200 Laurel Lake Drive

Major Site Plan to construct 7 duplex villa buildings

| Hudson Planning Commission | SITE PLAN REVIEW – LAUREL LAKE VILLAS |
| Case No. 25-229            | June 9, 2025                          |

**Fig. 1 - June 9, 2025 PC Submittal**

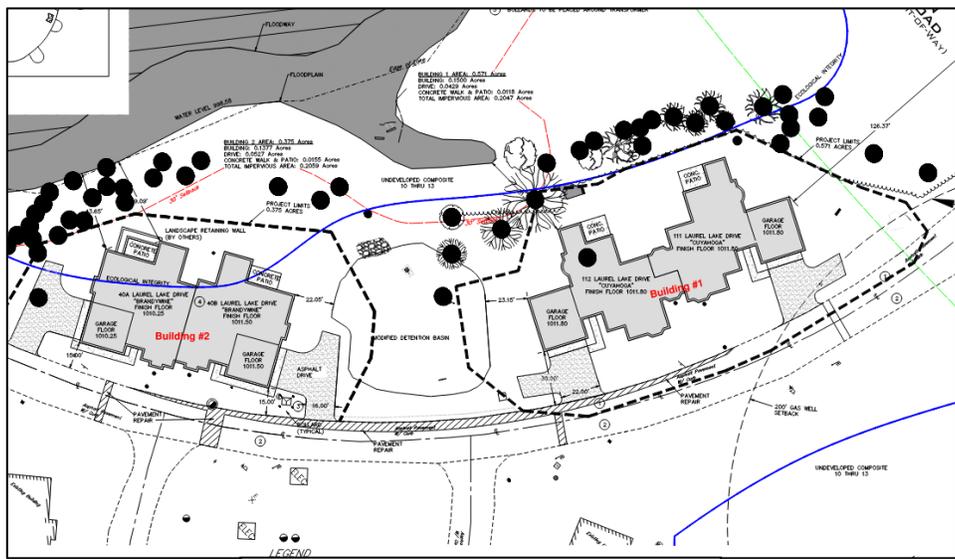
1. Buildings #1 and #2 have been repositioned. Building #2 has been redesigned to a duplex with side loaded garages and is located further from the access drive. The proposed stormwater pond has been reconfigured.

Fig. 3 June 9, 2025 PC Submittal

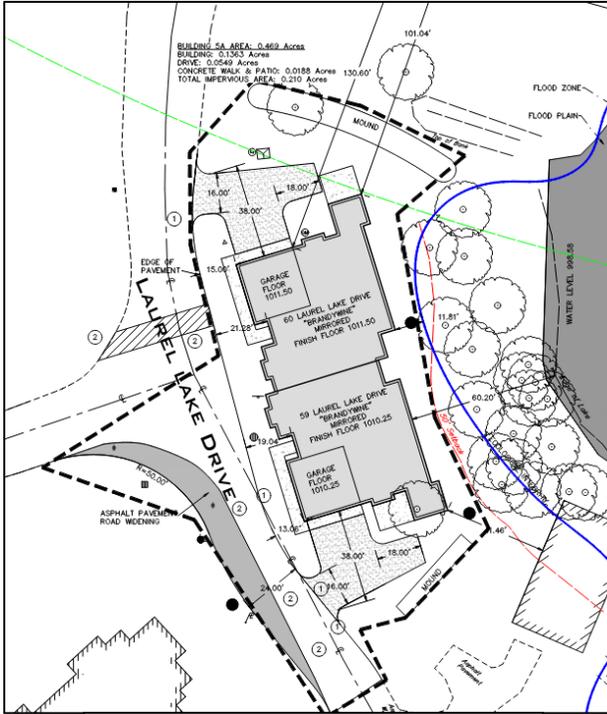
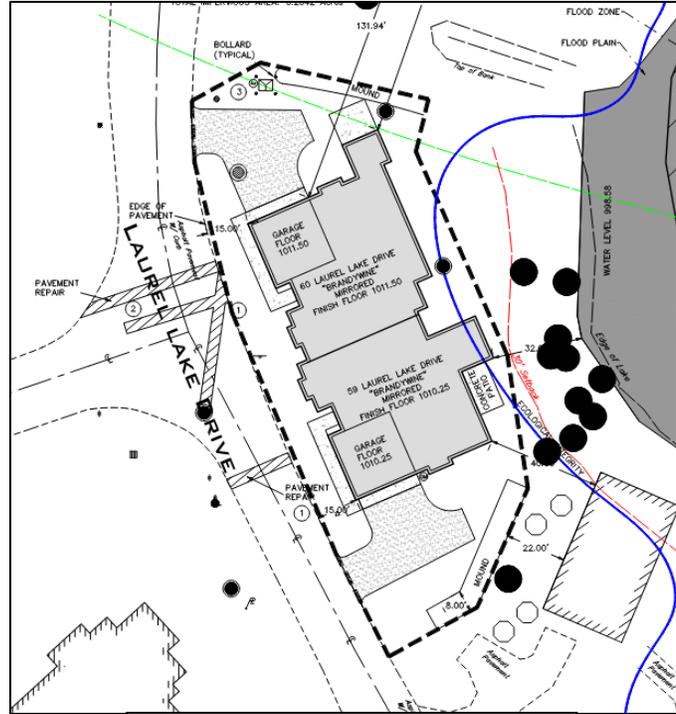
2. The applicant is no longer requesting to realign the access drive. The building has been slightly redesigned allowing the existing drive to remain in place.

**Fig. 4**

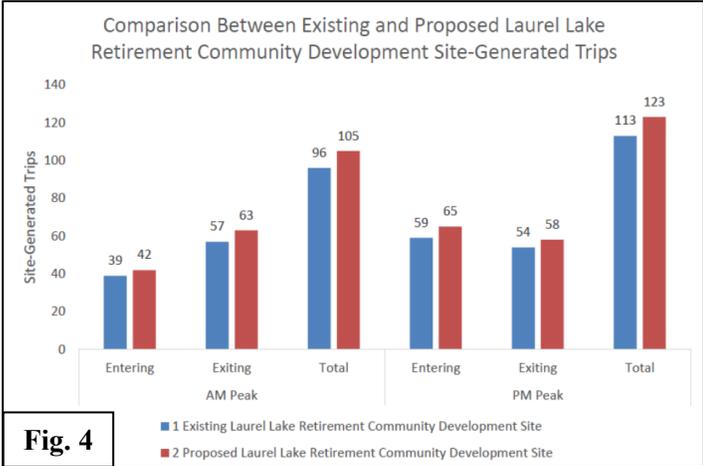
- The number of anticipated vehicle trips would be low per the following chart (See Figure 4).
- The proposed driveways and resulting sight distances would meet the most recent edition of the *Federal Manual of Traffic Control Devices 11th Edition, December 2023*.

Fig. 5

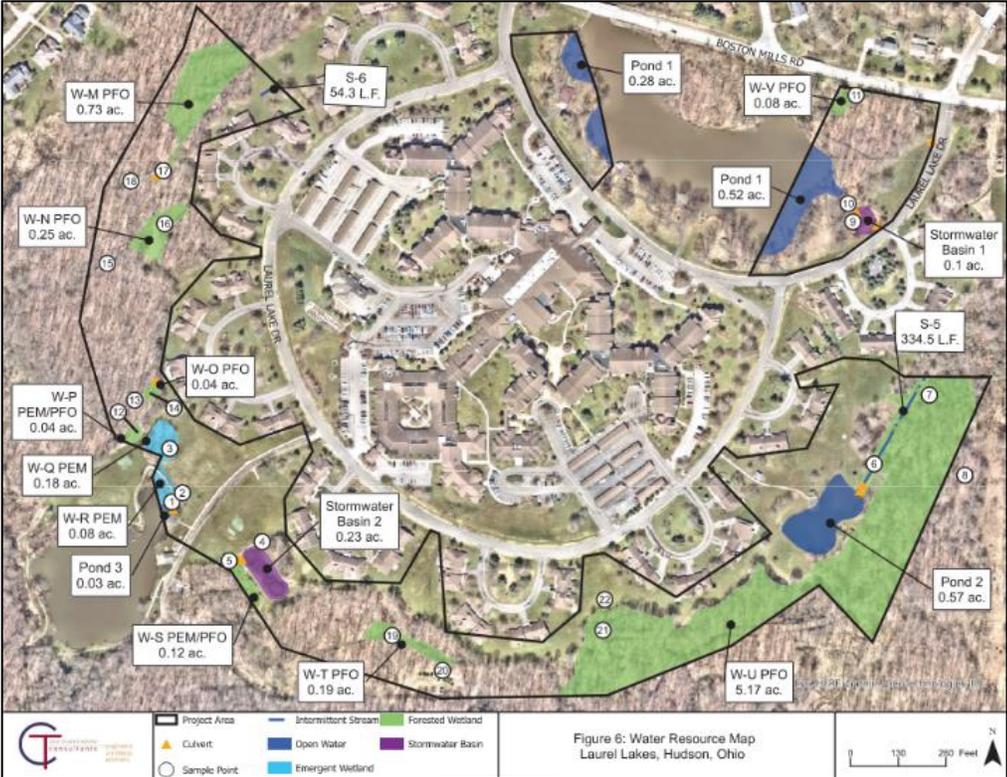
Updates to Application: The applicant has submitted a letter with the current Planning Commission submittal. The letter was written by Carrie Ricker, Project manager and profession wetland specialist, of Verdantas (formerly CT Consultants), the environmental science and engineering firm that has completed the environmental documentation for the site . The letter states: *Verdantas, LLC (formerly CT Consultants, Inc.) prepared the Wetland Delineation Report for the Laurel Lake, Hudson, Ohio property in August 2022. We have been requested to provide clarification around Pond-1 jurisdiction and the type of surface water feature this is considered. Pond-1 as labeled on the attached Water Resource Map for Laurel Lake (see Figure 5)., is considered a tributary impoundment under (a)(3) of the Waters of the United States (WOTUS) Regulatory Ruling. Pond-1 does not contain wetland vegetation and is not considered a wetland by definition. This feature is an open water impoundment that extends upstream as a part of Lake Forest on the north side of Boston Mills Road. This feature is an impoundment of an unnamed tributary to*

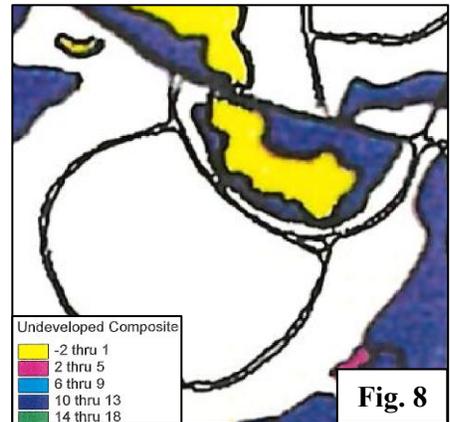
Update to Application: Staff notes minimal change to the site plan relative to this requirement; however, the applicant’s determination on the classification of the pond vs. wetland would relate to this analysis. Staff notes; while the pond shore area itself is classified under the lowest Index of Ecological Integrity Composite, the surround area falls under the two highest (see Figure 8). The applicant has labeled this area on the submitted site plans.
